CASE NO.: Historic Design Review Case No. HIS22-01

APPLICATION SUMMARY: A proposal to replace the exterior windows and add new security lighting and cameras on the exterior of the Anderson Building (c.1900).

REQUEST: Class 3 Major Historic Design Review of a proposal to replace the exterior windows and add new security lighting and cameras on the exterior of the Anderson Building (c.1900), a historic contributing building in Salem's Downtown Historic District, zoned CB (Central Business District), and located at 201-211 Commercial Street NE (aka 251-275 Court Street NE); 97301; Marion County Assessor's Map and Tax Lot number: 073W22DC09000.

SHEET:
A2.01

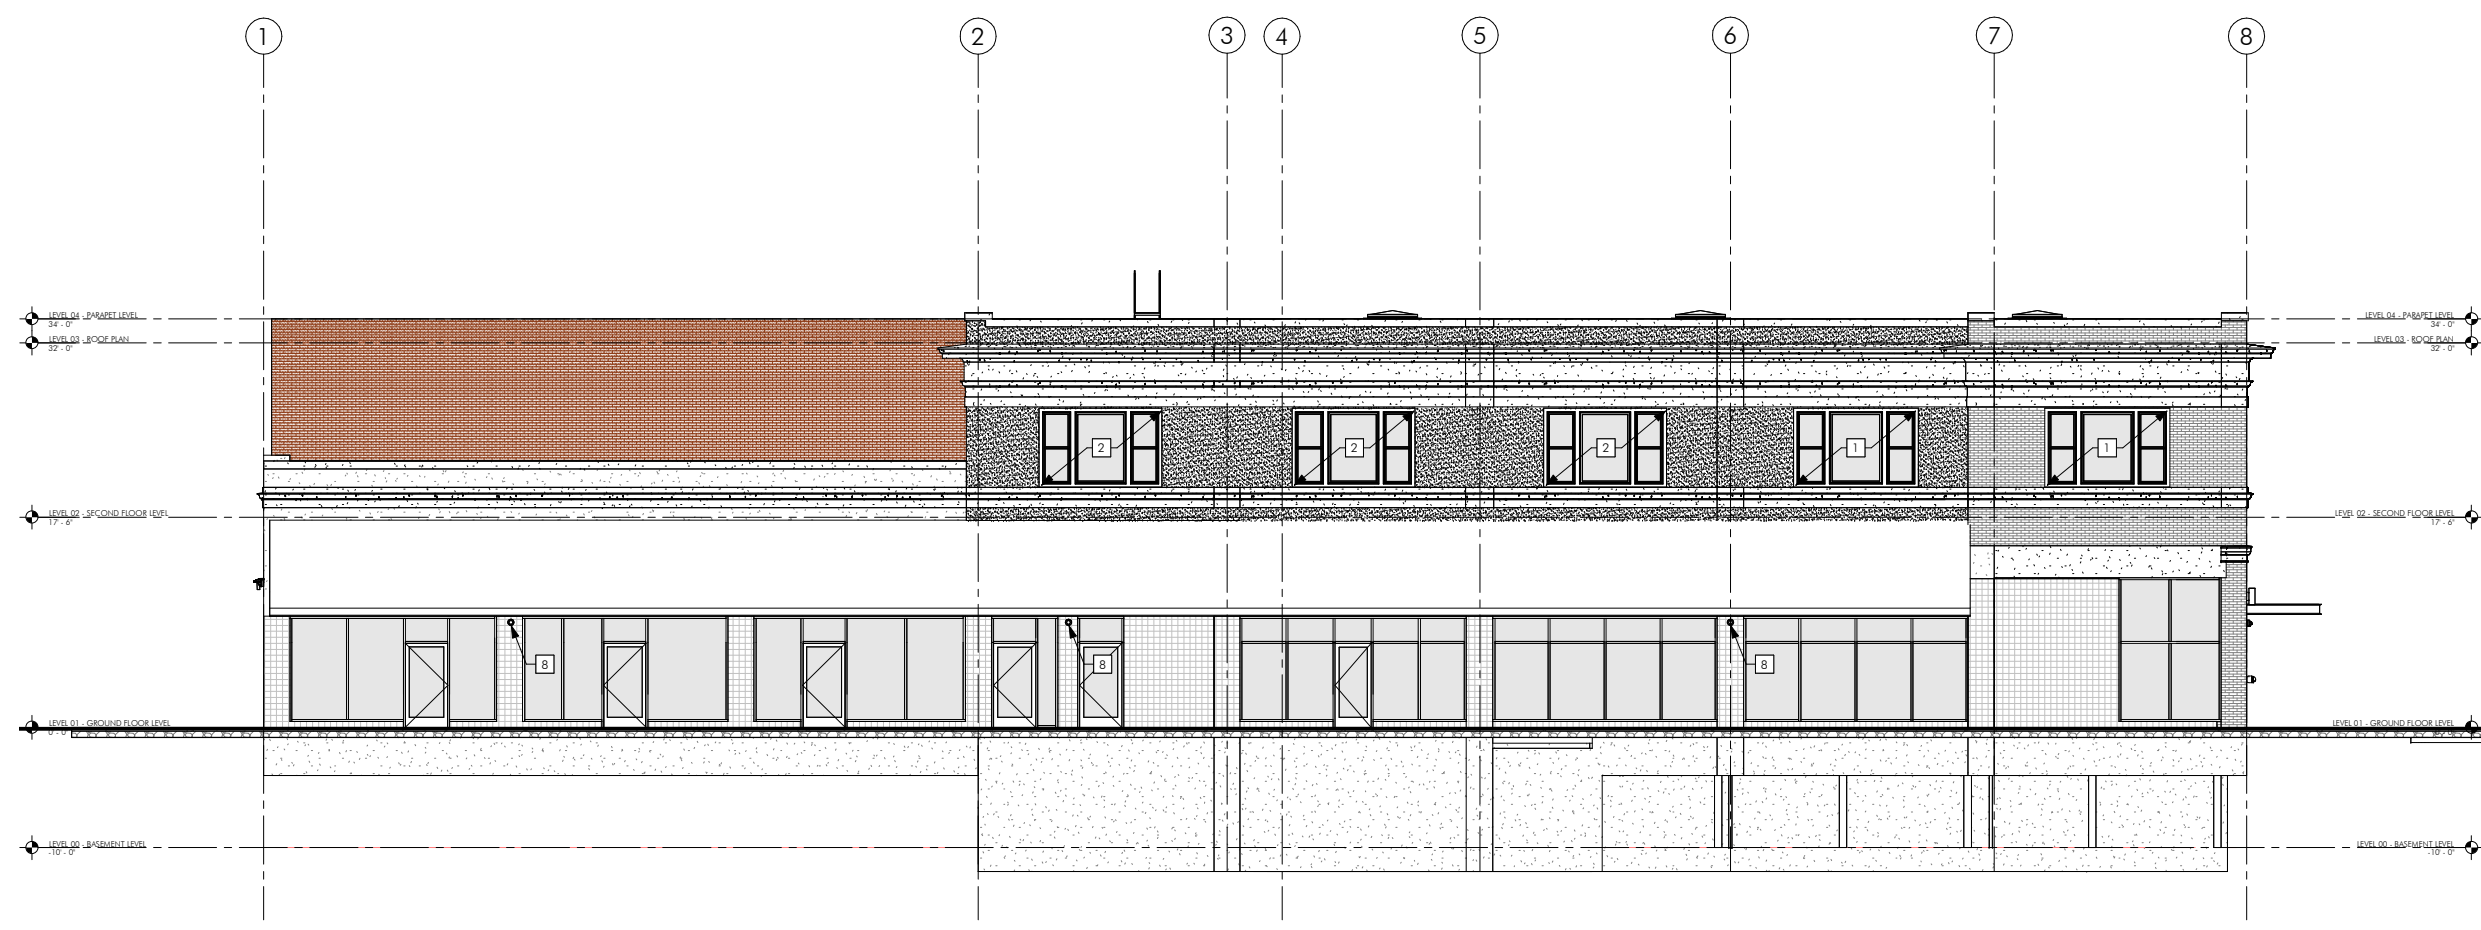
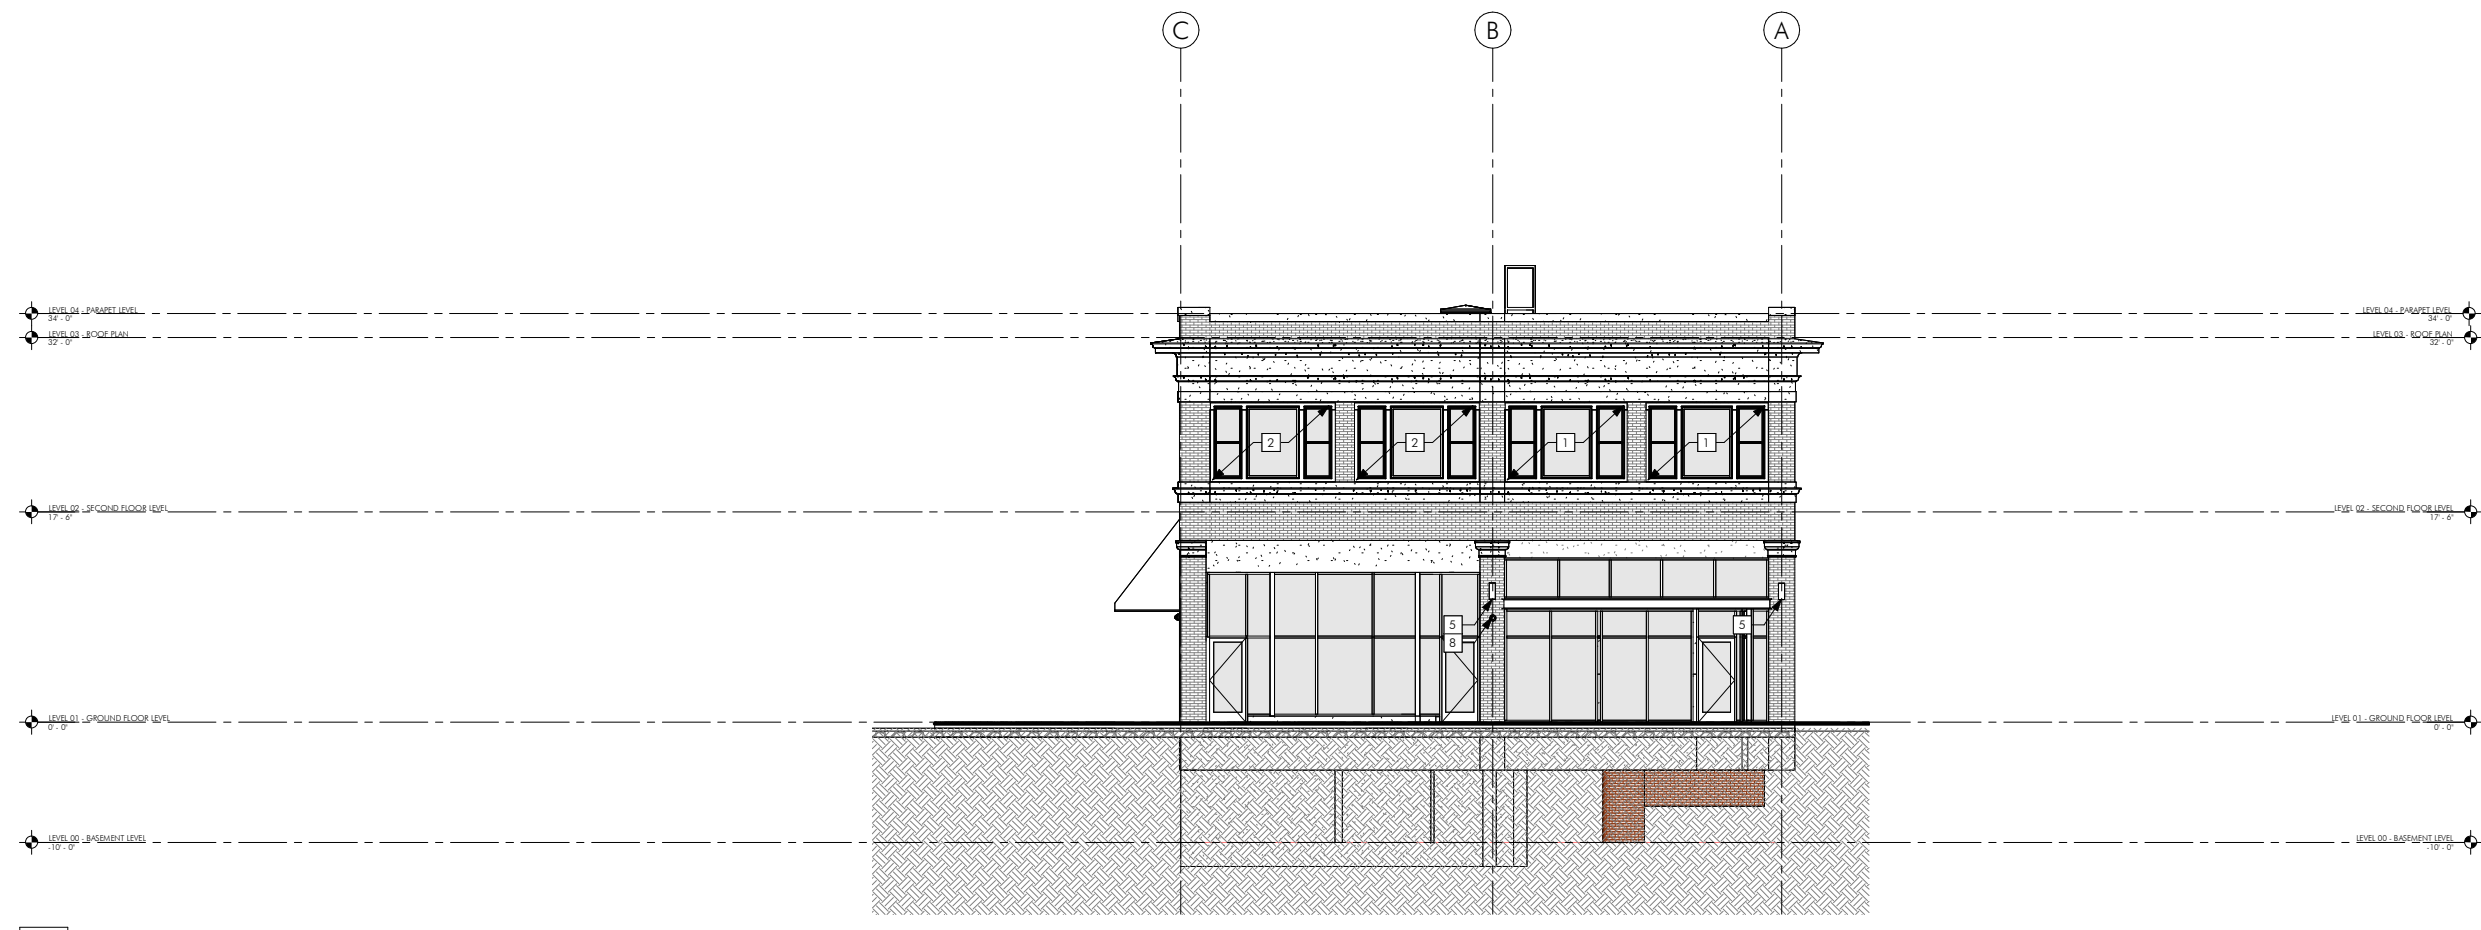
Finding: The proposed new security cameras and the replacement and new security lighting fixtures are located on the rear façade, screened by the existing awning or in an inconspicuous location on the exterior of the Anderson Building. The most visible fixtures are on the east façade fronting Commercial Street. The replacement security light fixtures for the eastern façade are of a 'box' design, where the light shines both up and straight down on the building façade, and where the light fixture appears to be an integral part of the overall building design. The fixtures will be installed into the brick columns, and in order to ensure that the proposal does not adversely impact any original materials on the exterior of the Anderson Building, staff recommends the HLC adopt the following Condition of Approval:

Condition 1: The proposed new security cameras and lighting fixtures shall be attached into mortar joints and not into the brick masonry on the columns on the exterior of the Anderson Building.

Finding: The applicant is proposing to install new security cameras and lighting at the rear of the Anderson Building and screened by the existing awning on the south façade. The replacement and new fixtures are small in scale, and where visible on the eastern façade, no character defining features are obscured or damaged by their installation. Staff recommends the HLC find that SRC 230.040(j)(2)(B) has been met for this proposal.

Finding: The applicant is proposing to install new security cameras at street level underneath the existing awning, so these cameras will be screened from view facing Court Street NE. The proposed new cameras and replacement security lights are small in scale on the facades fronting Commercial Street NE and the alley at the rear, and while not screened, the new fixtures will not obscure any character defining features. Staff recommends the HLC find that SRC 230.040(j)(2)(F) has been met for this proposal.

Condition 1: The proposed new security cameras and lighting fixtures shall be attached into mortar joints and not into the brick masonry on the columns on the exterior of the Anderson Building.

1 WINDOW ASSEMBLY ELEVATIONS

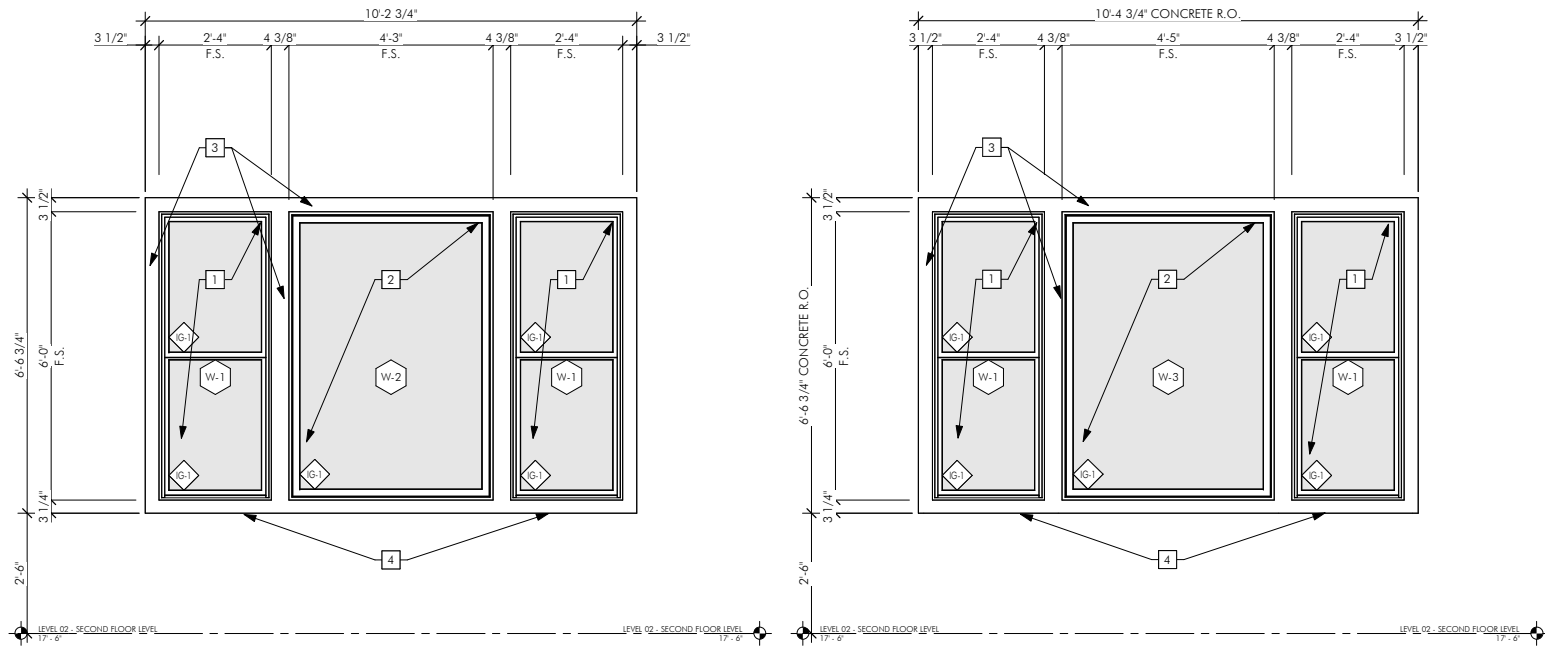
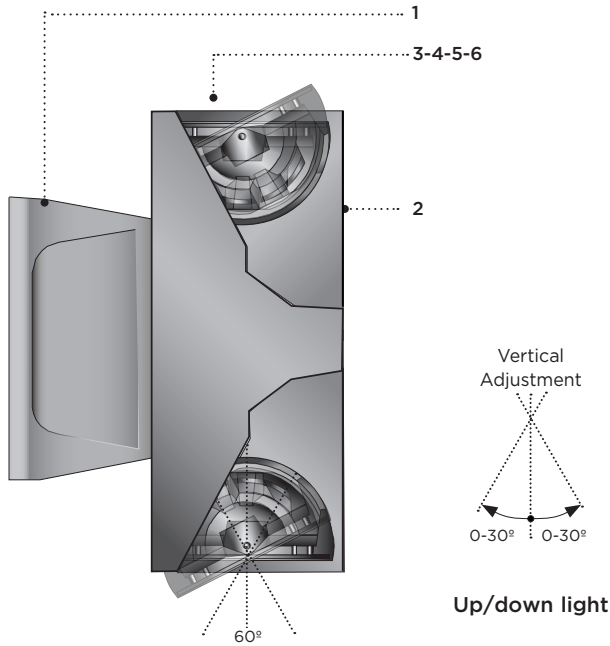
Finding: The applicant is proposing to replace the existing wood frames, sills and trim with wood, matching the existing to the greatest degree feasible. The aluminum storm windows will not be replaced, instead the applicant is proposing to replace the existing wood windows with fiberglass with insulated Cardinal LoE 366 glass which is similar to the glass within the storefront on the first floor. The proposed new windows will be installed within the existing openings and match their current design and configuration. Staff recommends the HLC find that SRC 230.040 (b)(1)(B) has been met for the proposal.

Finding: The applicant is proposing to install replacement windows which match the configuration and design of the 1927 windows on the second-floor windows of the Anderson Building. The windows will be installed into the existing openings and they will be framed and trimmed with wood, matching the existing to the greatest degree feasible. While the windows will be fiberglass and not wood, the fiberglass is paintable, and therefore will not have the reflective qualities of a more modern window. Staff recommends the HLC find that SRC 230.040(b)(2)(A) has been met for the proposal.
